Service Bulletin

RRP Service Bulletin No: RRP SB362

Title: Cummings Engine Door Grab Handle Kit

Product Series: Dual Anchor Spreader Plate [DASP] & Advanced Tie Plate Inserter [ATPI] with Cummings 3.8 engines.

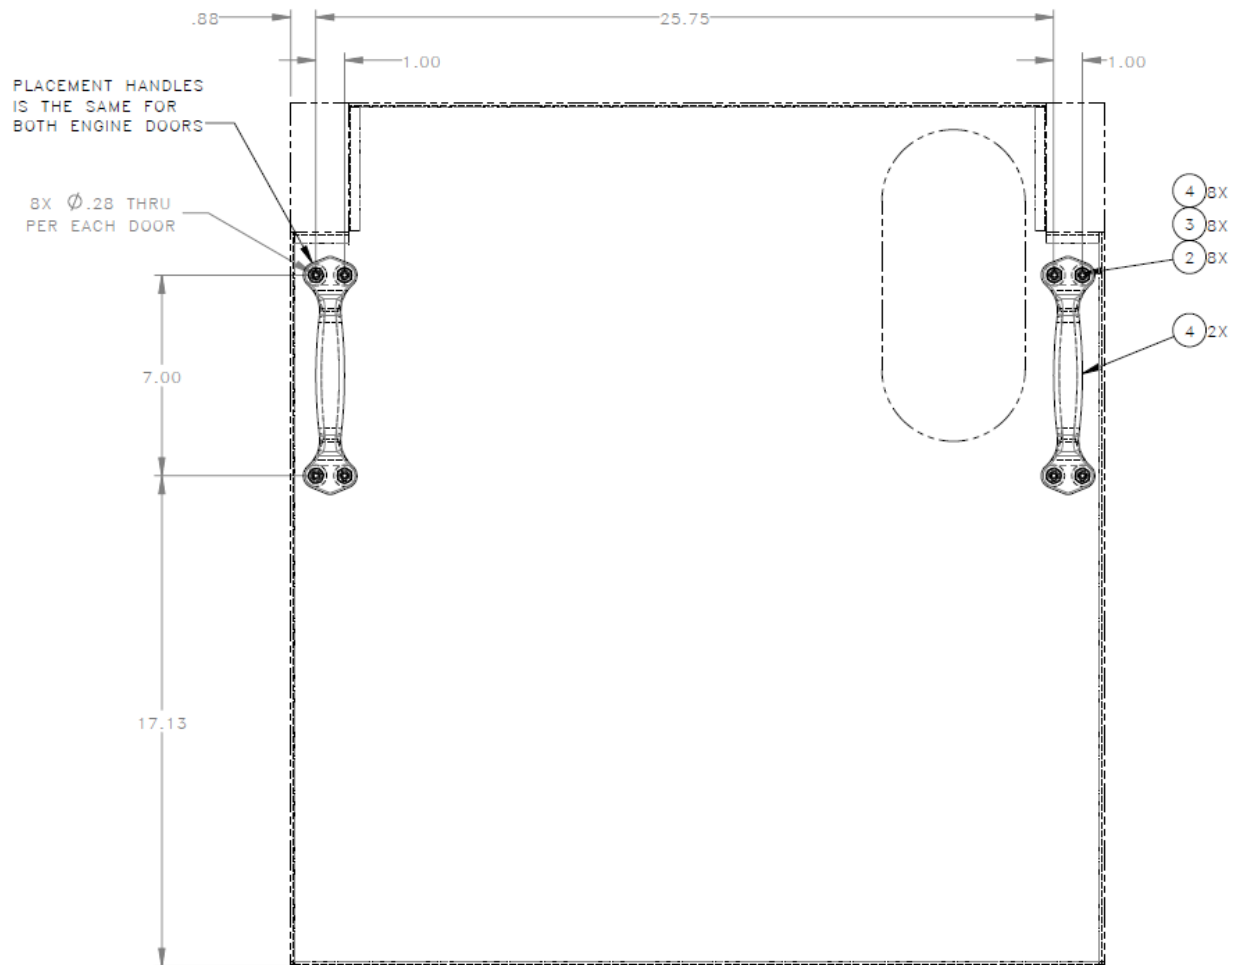
Summary: Engine Doors Grab Handles Kit available to make removing the engine panel easier.

Action: Install the Engine Doors Grab Handles Kit, RRP# 793099.

Kit, Engine Doors Grab Handle / RRP 793099 [Rev 1 (12.2020)]

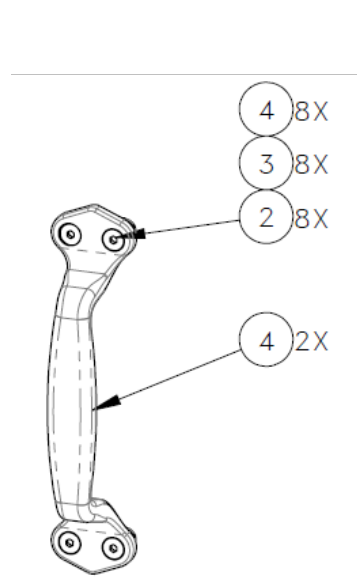
1. When engine is not running remove both side doors on the engine (for clarity only one door is shown).
2. Drill clearance holes as directed.
3. Mount Engine Doors Grab Handles Kit (RRP P/N 793099).
4. Reattach doors to engine.
